Item ID: D3394-043

Work Order ID 165022

D3394-041/-043 LUG ASSEMBLY

DRAWING NO.	D3394	TITLE	LUG	REV. B	DART AEROSPACE LTD ENGINEERING ORDER	D.E.O. NO.	D3394-B-1	SHEET NO.	SHEET 1 OF 1	SCALE	NTS
DRAWN	AJS	CHECKED			MFG. APPR.	APPROVED		DE APPR.			
DATE	09.11.04	DATE	09.11.04	DATE	09.11.04	DATE	09.11.04	DATE	09.11.04

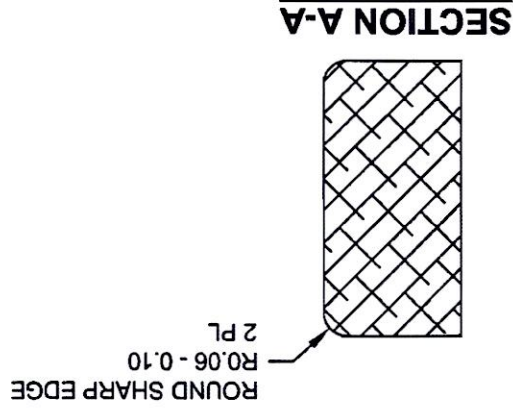
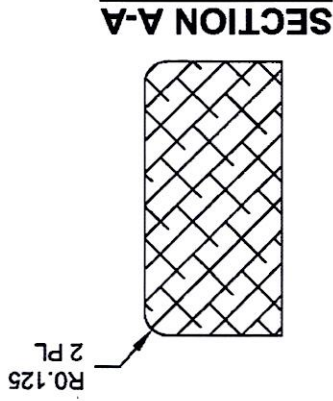
SHEET 4 ZONE A,1 MODIFY SECTION A-A AS SHOWN:

REASON: DRAFTING ERROR

IS:

DRAWING NO. D3394	TITLE LUG	REV. B	DART AEROSPACE USA, INC ENGINEERING ORDER		D.E.O. NO. D3394-B-2	SHEET NO. SHEET 1 OF 1	SCALE NTS
DRAWN <i>GP</i>	CHECKED <i>Sc</i>	MFG. APPR. <i>M</i>	APPROVED <i>MP</i>		DE APPR. <i>MP</i>		
DATE 11.05.02	DATE 11.05.09	DATE 11.05.08	DATE 11.05.08		DATE 11.05.09

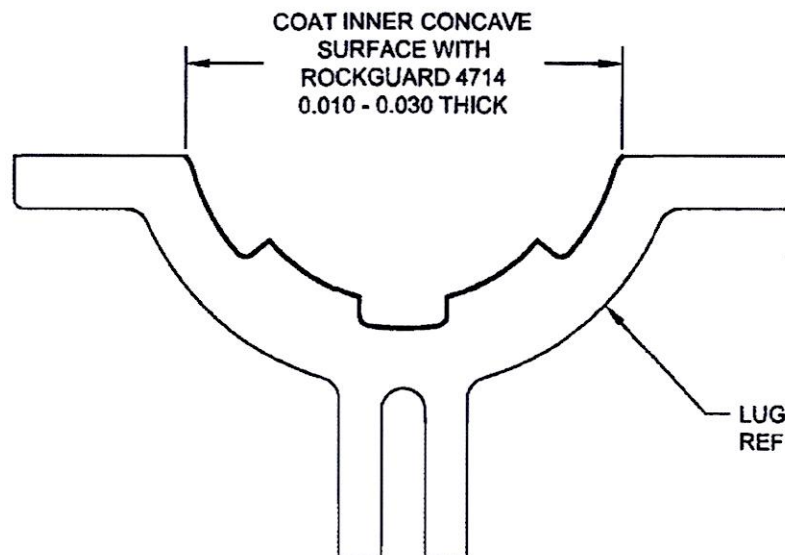
ADD D3394-xRG OPTION

D3394-xRG MOUNTING LUGS ARE INDENTICAL TO D3394-x MOUNTING LUGS, HOWEVER AFTER FINISH, COAT INNER CONCAVE SURFACE WITH "PLUS ONE ROCKGUARD 4714" AS SHOWN BELOW.

D3394-1RG LUG (SHOWN)
D3394-3RG/-5RG LUGS (SIMILAR)
D3394-041RG/-043RG/-045RG LUG ASSEMBLIES (SIMILAR)
